**BRITISH LEYLAND MOTORS INC.**  
 600 Willow Tree Road • Leonia • New Jersey 07605

SUBJECT: Forward Clutch Plate End Float	MODELS: Austin America Automatics
---	-----------------------------------

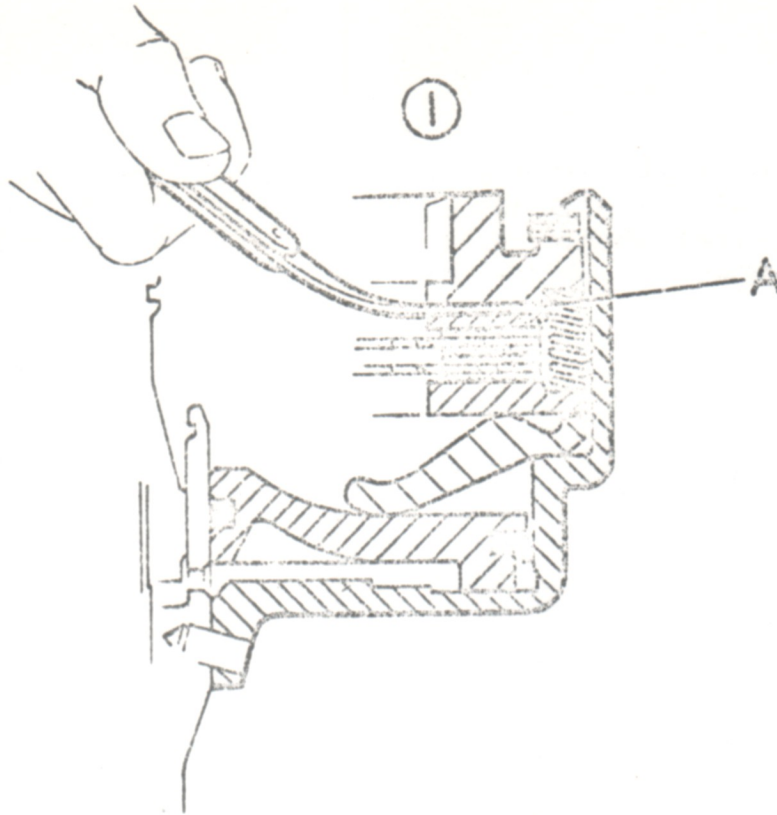
To reduce free piston travel and provide optimum clutch performance, 0.010 in. (0.26 mm) shims, Part #37H 4522, have been introduced between the end plate and Spirolox retaining ring from the following new engine prefix range:-

In the event of transmissions or clutches being dismantled from engines having prefixes prior to the above range, shims must be fitted as detailed below to ensure that clutch plate and float does not exceed 0.010 in. to 0.020 in. (0.26 mm to 0.52 mm):-

- (1) Remove Spirolox retaining ring, end plate, one friction plate and intermediate plate. (It is not necessary to remove springs, but ensure that the piston is pushed down to the bottom of its bore.)
- (2) Replace friction plate, intermediate plate, end plate and Spirolox retaining ring IN THIS ORDER FOR THE PURPOSE OF CHECK ONLY.
- (3) Using feeler gauges, measure and note gap 'A', Fig. 1, between end and intermediate plates as illustrated below. From this measurement subtract 0.010 in. to 0.020 in. to arrive at the number of shims required.
- (4) Remove once again the aforementioned parts and replace them in the correct sequence AS ORIGINALLY REMOVED FROM THE CLUTCH, adding the number of shims required as calculated in paragraph 3, underneath the Spirolox retaining ring.

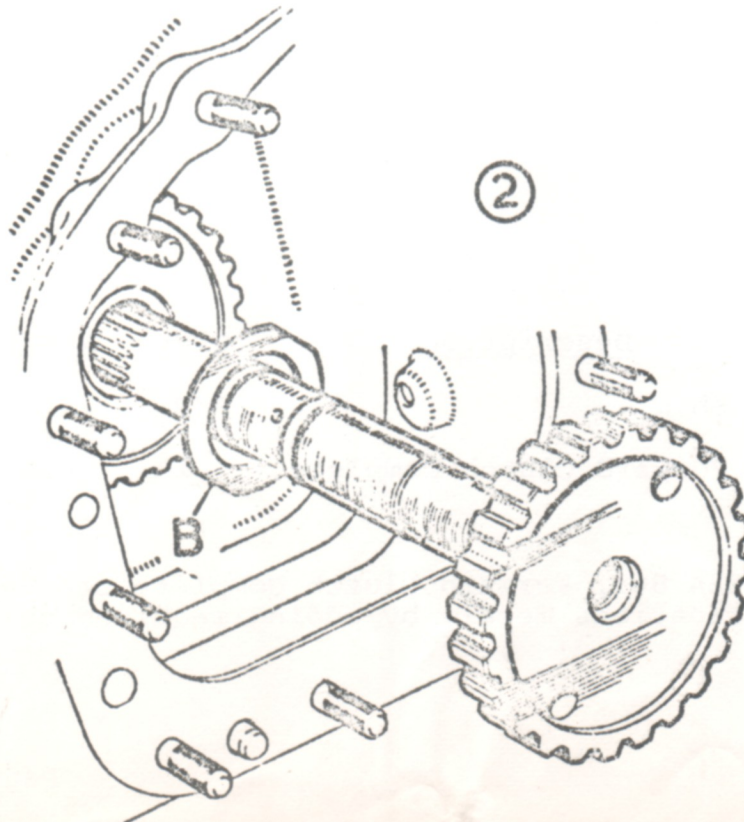
- (5) If the clutch piston has been marked by contact with the forward output shaft, the piston should be replaced. Check also if thrust washer 'B', Fig. 2, between forward output shaft and forward clutch hub is excessively worn or damaged and, if so, it should be replaced.

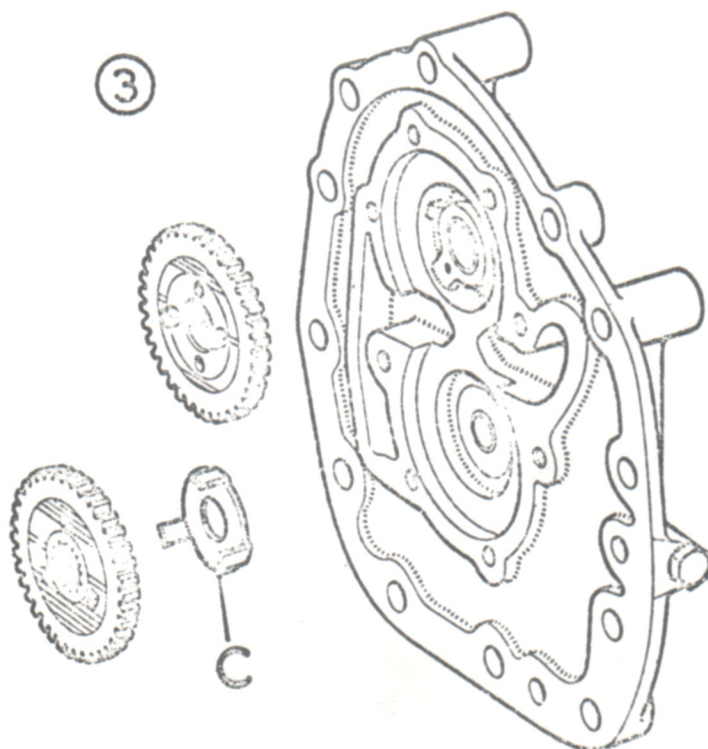
- (6) Remove and dismantle the auxiliary pump and governor assembly as detailed in Workshop Manual Section Fa. 5 and check thrust washer 'C', Fig. 3. If excessively worn or damaged, it should be replaced.
